## JOINT REGIONAL PLANNING PANEL (Northern)

JRPP No	2014NTH005
DA Number	T6-14-67
Local Government Area	Kempsey Shire
Proposed Development	Establish an extractive industry on a former extractive industry site, with a quarry area of about 9.0ha, and extending about 17m below the existing depth with annual production of 450,000 tonnes with a quarry life of up to 30 years.
Street Address	204 Crescent Head Road, South Kempsey  Lot 1 DP 914805, Lots 14 and 16 DP 1157615 and Lots 186, 187 and 189 DP 754400
Applicant/Owner	Applicant: NSW Quarry Services PL  Owner: Kempsey Shire Council
Number of Submissions	9
Regional Development Criteria (Schedule 4A of the Act)	Clause 8 of Schedule 4A lists determination of applications for extractive industries that are designated development to be a council function that is able to be conferred on a JRPP.  Under clause 21 of State Environmental Planning Policy (State and Regional Development) 2011, the JRPP is the consent authority for the determination of any application for an extractive industry that is designated development.

## Assessment Report and Recommendation

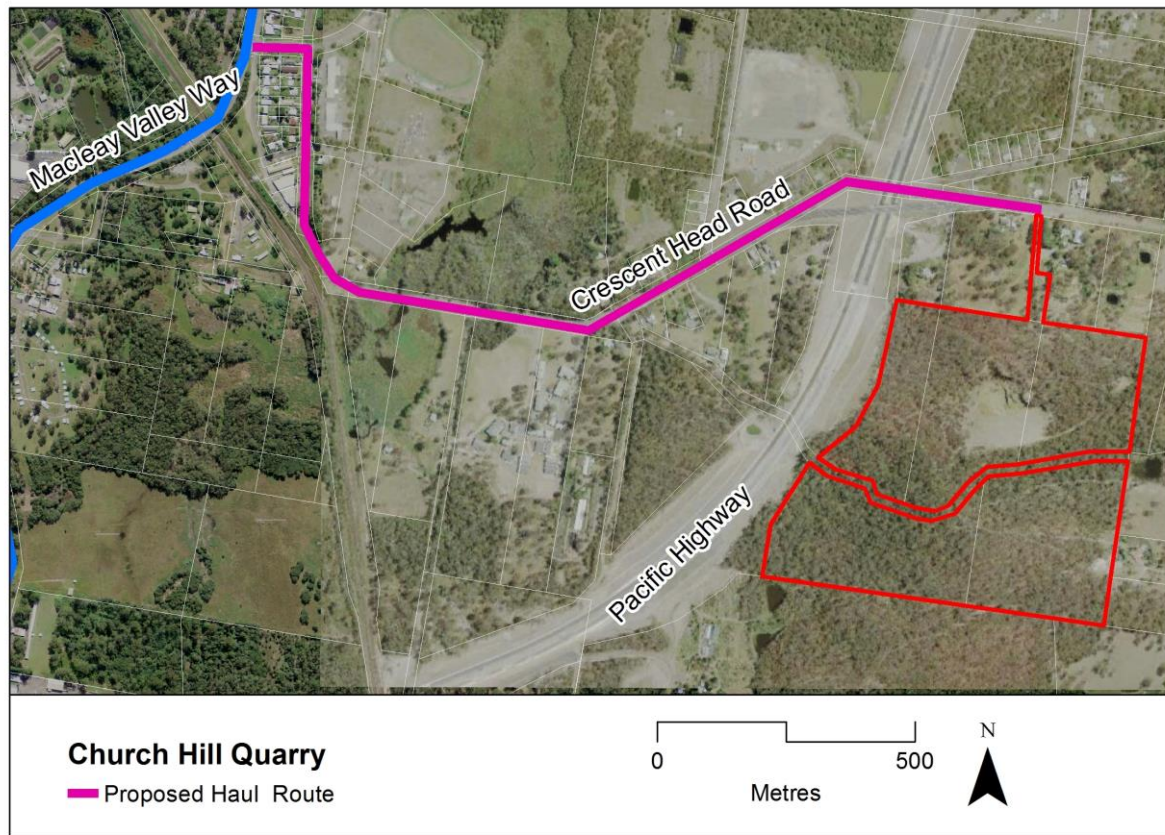
The assessment of the application resulted in the following recommended modifications to the development:

- Reduction of the quarry footprint to exclude any land within 150m of any existing residence,
- Reduction in the quarry footprint to provide a minimum 50m setback from the northern boundary of Lots 186 and 187 DP 754400, and
- Adjustment to the location of the internal access road so that the construction is not closer than 140m to dwelling R5.

The effect of these changes is shown below.
